# Moolarben Coal Project Stage I Optimisation Modification

## Response to Submissions

Report J12090RP1 | Prepared for Moolarben Coal Operations Pty Limited | 10 September 2013

Figure I.1

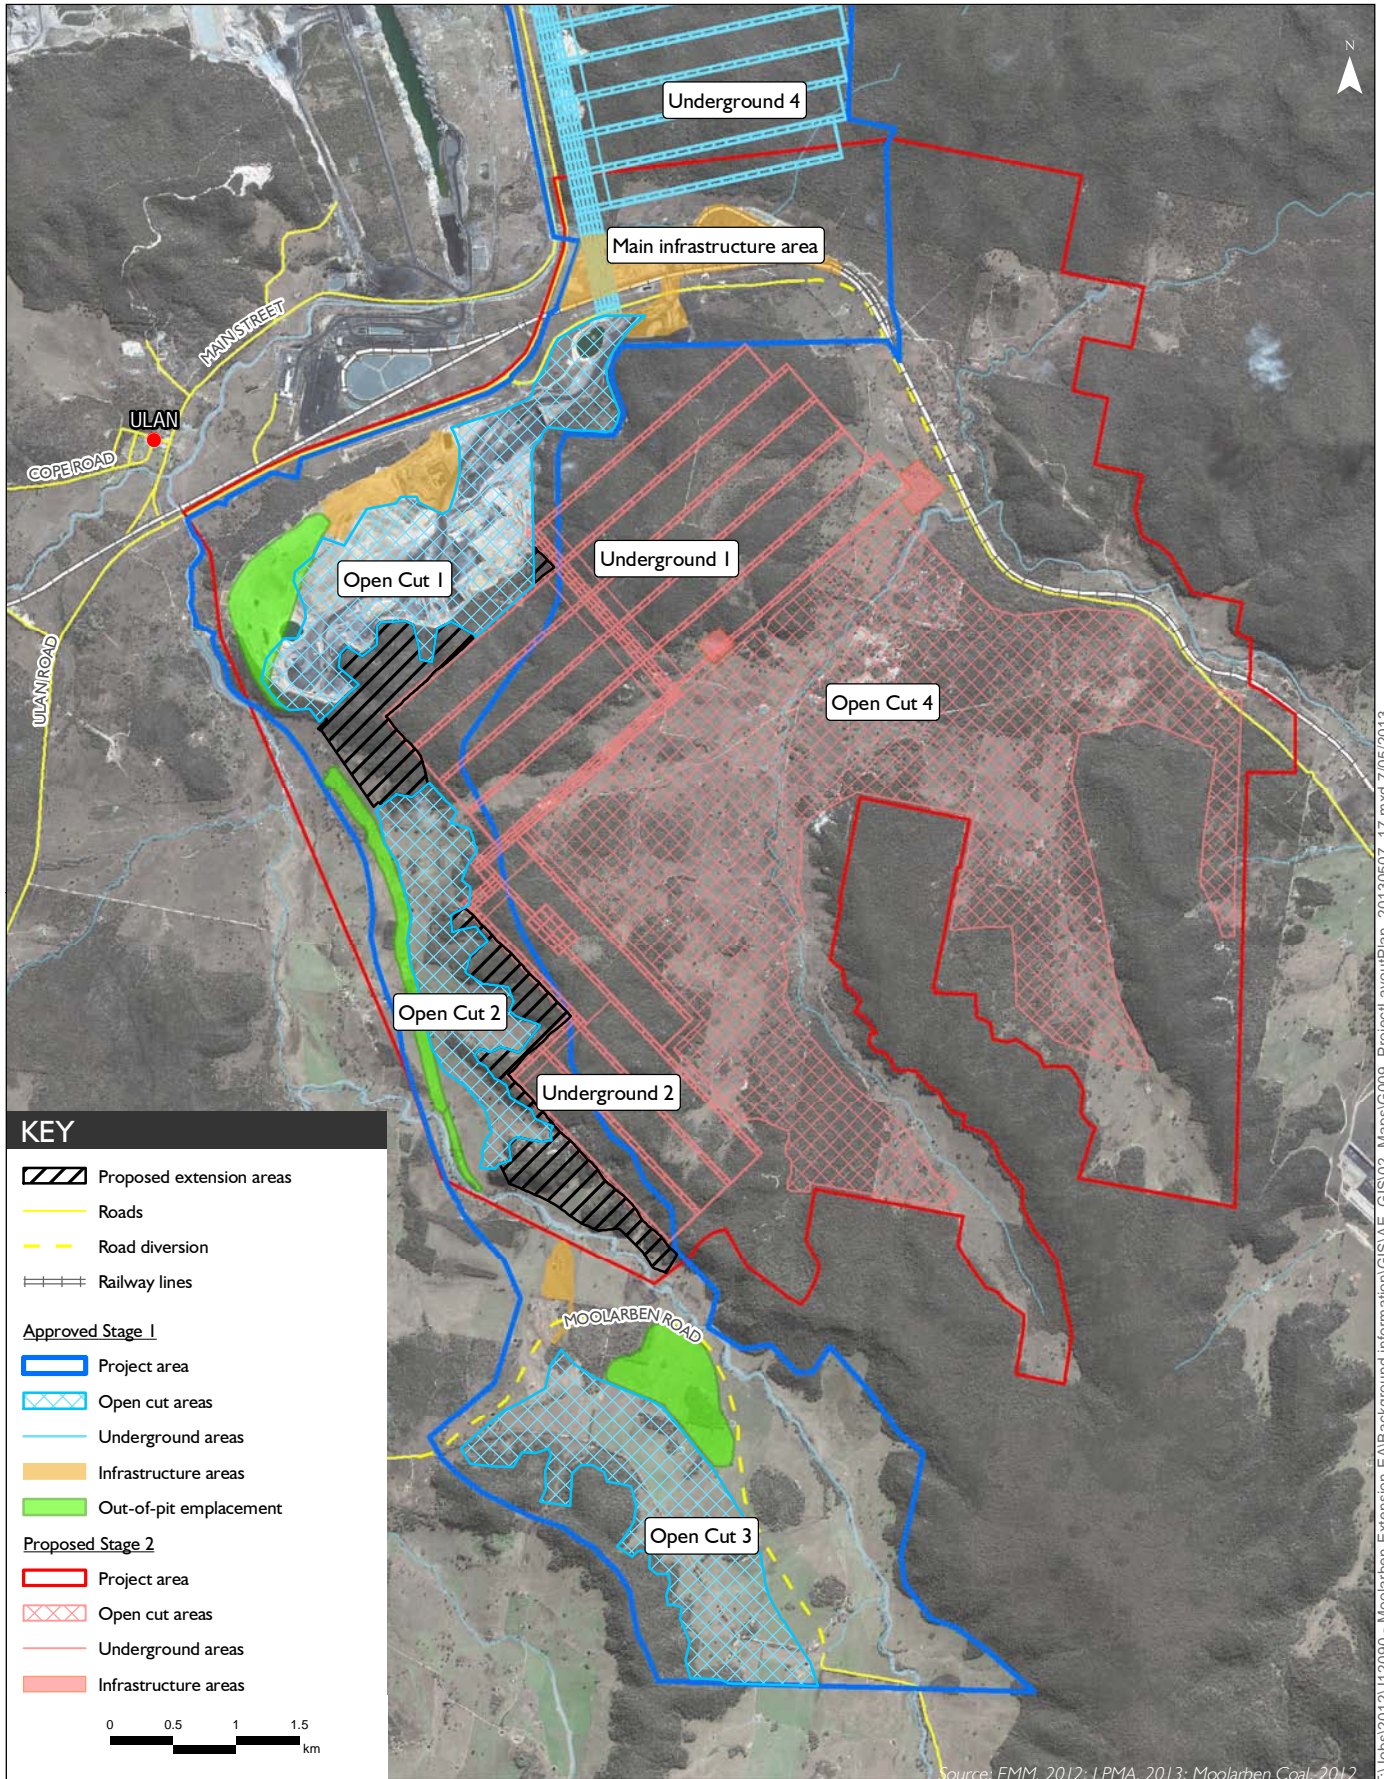
One submission (submission S5) received from Xstrata Coal notes that two of the figures in the EA (Figure ES.1 and Figure 1.1) do not depict the correct Ulan Coal Mine project approval boundary and two other figures (Figure ES.3 and Figure 10.3) do not display all of the Ulan Coal Mine biodiversity offset areas.

Xstrata Coal's comments are noted and, accordingly, these figures have been amended. The site location plan (Figure 1.1 above) displays the correct Ulan Coal Mine project approval boundary and the offset areas which relate to other mines have been removed from the biodiversity offset plan provided in Appendix D.

## 2.4 EA amendments and revision

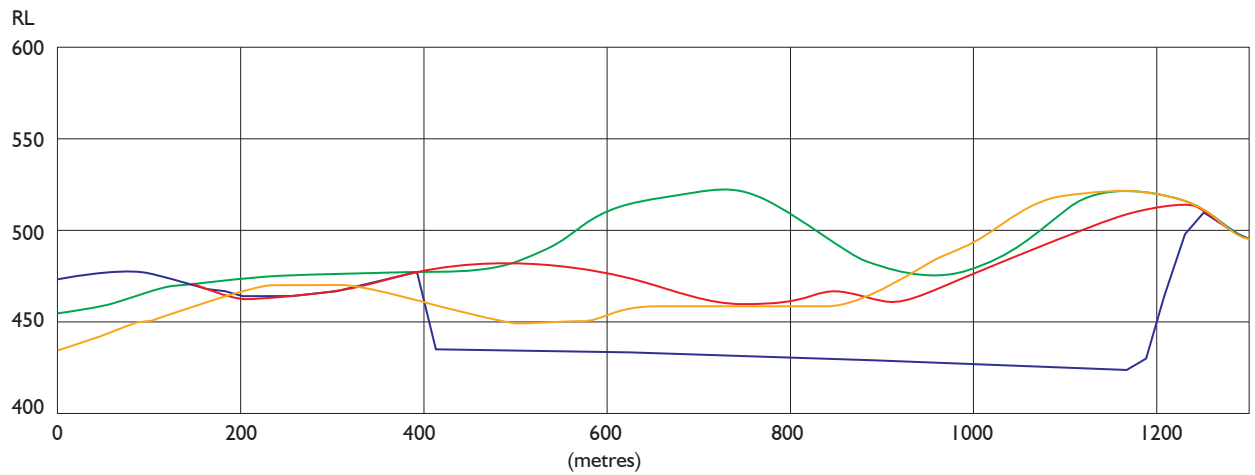
It is also noted that the indicative open cut mine plan for year 16 (Figure 4.4 in the EA) does not show the full extent of rehabilitation. Figure 4.4 has been amended and is also provided in Appendix D.

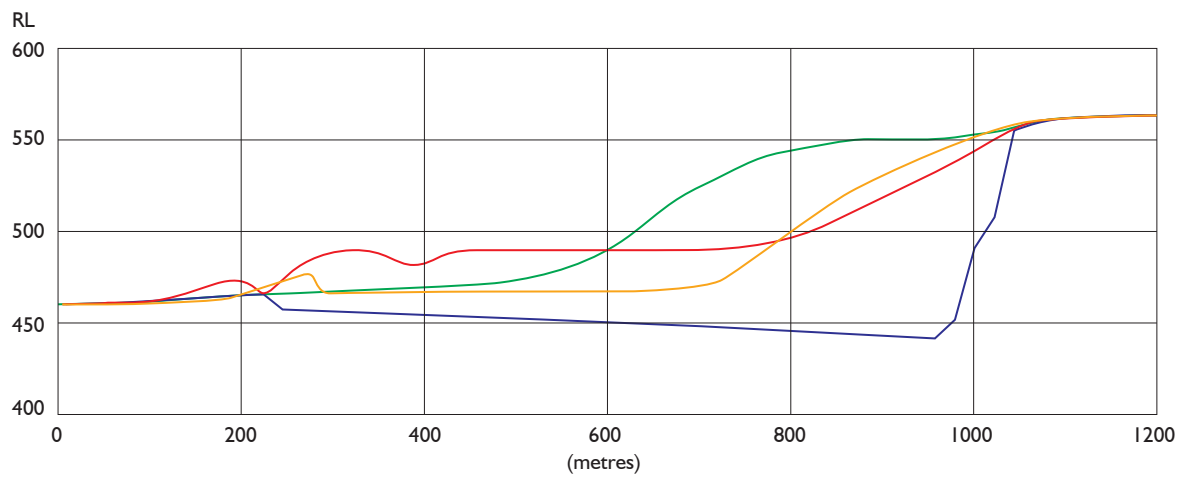
Figure 4.7 in the MOD9 EA has been amended to include a Stage 1 approved landform line. The revised figure is provided in Appendix D.
